Access Compliance Report

Public Rights-of-Way

(Pedestrian Signals)

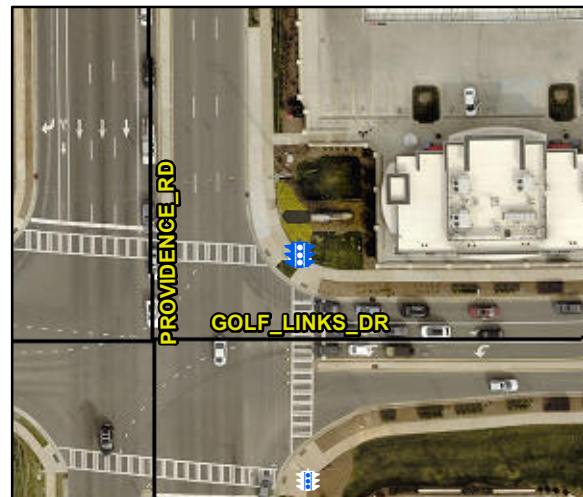
PROW/ADA: TMUTCD 4e.08, R404.2, R404.3, R406.2, R404.7.2

N/A	B 1 Clear Xing Direction?	Yes	N/A	B 2 Clear Xing Direction?	N/A
	B 1 Crossing Direction	To W		B 2 Crossing Direction	N/A
Yes	B 1 DistanceTo XWalk (in)	0.0	N/A	B 2 DistanceTo XWalk (in)	N/A
No	B 1 DistanceTo Curb (in)	78.0	N/A	B 2 DistanceTo Curb (in)	N/A
Yes	B 1 Diameter (in)	2.0	N/A	B 2 Diameter (in)	N/A

Possible Solutions: Replace Signal Push Button With APS Button on New Post. Remove & Relocate Sign.
